RESTORATION PLANS

FOR GOODERHAM AND WORTS

CASE GOODS BUILDING AND THE CANNERY BUILDING

(BUILDINGS 58, 59 AND 74)

West Elevation, Type 1

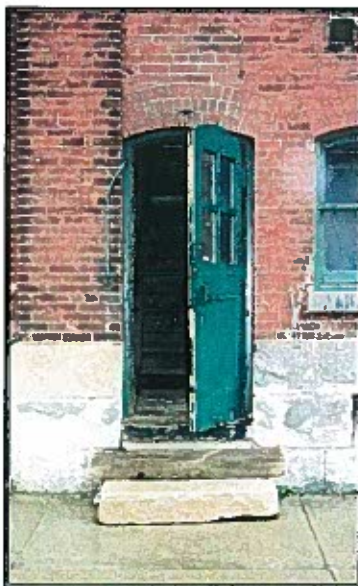
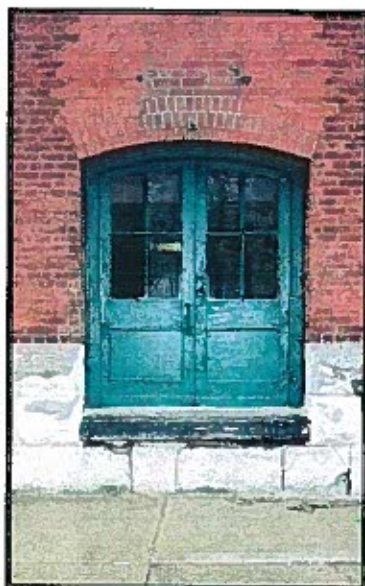
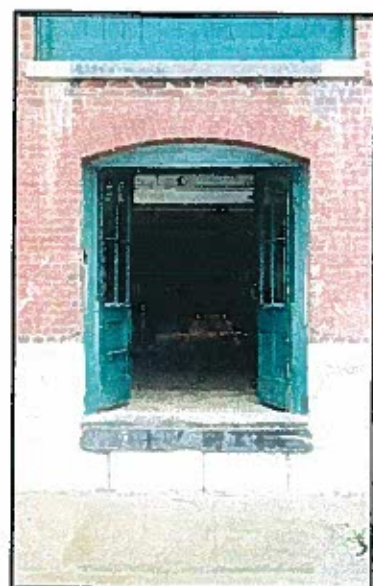
The existing ground floor is being lowered approximately 3 feet. In order to compensate for the ground floor alteration and barrier free access, 7 door sills on the ground floor will also be lowered. Zeidler Grinnell's application specifies that the doors must swing out which is contrary to Report 12 which identifies the doors to swing in. A resolution of these considerations is being reviewed by Leber Rubes.

Our second concern is related to the proposed transom indicated to be installed above the existing door once they have been lowered. Each door on the west elevation (as seen below) is unique and will require detailed drawings to verify how the transom will resolve the existing door frame and the brick archway above.

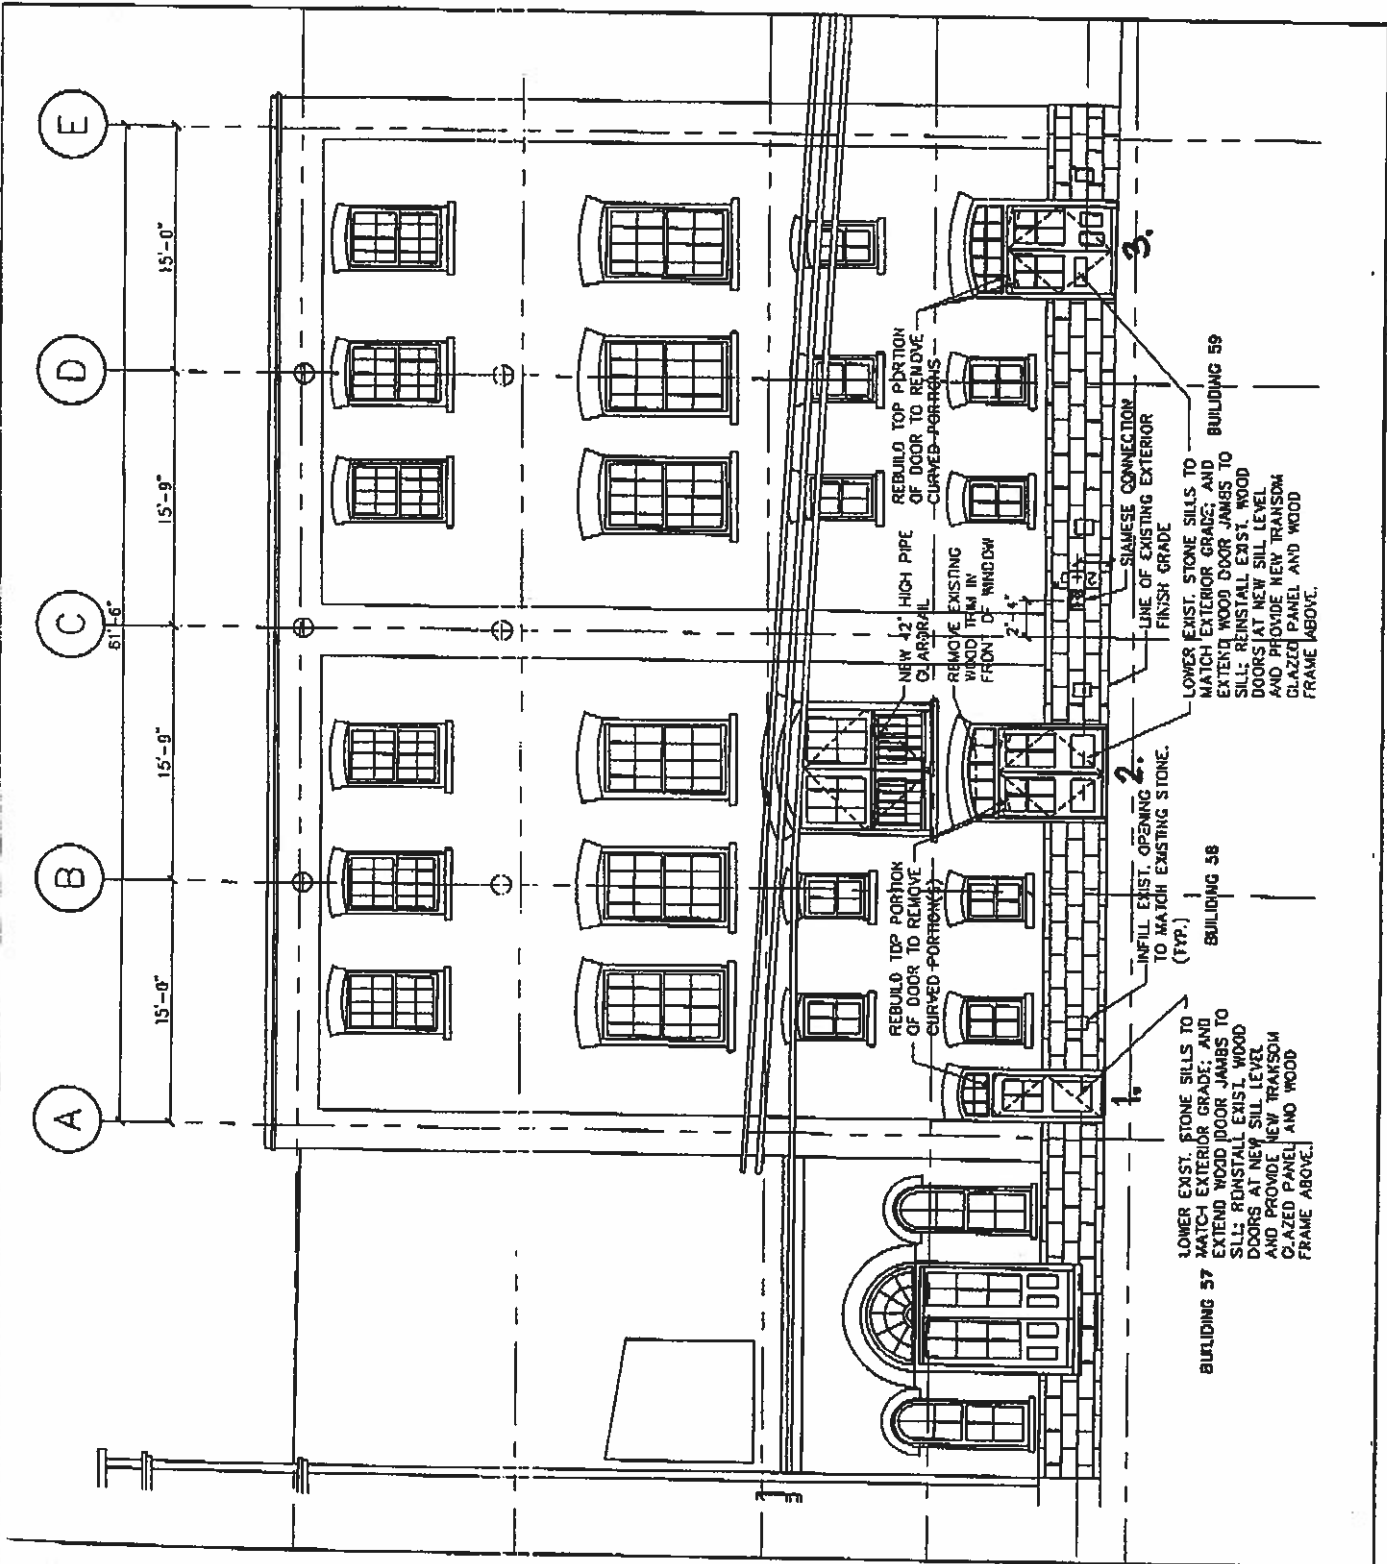
This is to confirm that it is our opinion that the removal of the knee walls below the ground floor of the Cannery Building will not adversely affect the structural integrity of the building.
